GROUP Transmission	MODEL 2019MY Niro (DE EV)
	NUMBER PS639	DATE December 2019

SUBJECT: TRACTION MOTOR – GEAR DRIVE ASSEMBLY CONNECTING BOLT SPEC CHANGE

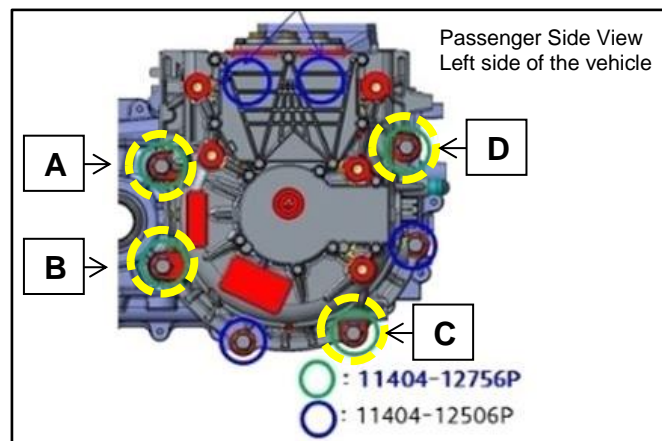
This bulletin provides information on the installation of the four (4) longer (75mm) connecting bolts between the Traction Motor and Gear Drive Assembly on some 2019MY Niro (DE EV) produced before May 13, 2019, which is noted in the EPC when ordering a traction motor assembly for replacement.

- When replacing the traction motor assembly, install the longer 75mm bolts in the specified locations shown for bolt(s) A, B, C and D.
- Replace the four (4) existing (50mm length) gear drive assembly connecting bolts (A, B, C and D - P/N 11404-12506P) shown with the longer (75mm length) bolts (**P/N 11404-12756P**) and torque to the specification provided below.

**Torque specifications for all traction motor retaining bolts:
58.6 – 71.6 lb.ft (79.4 – 97.1 Nm., 8.1 – 9.9 kgf.m)**
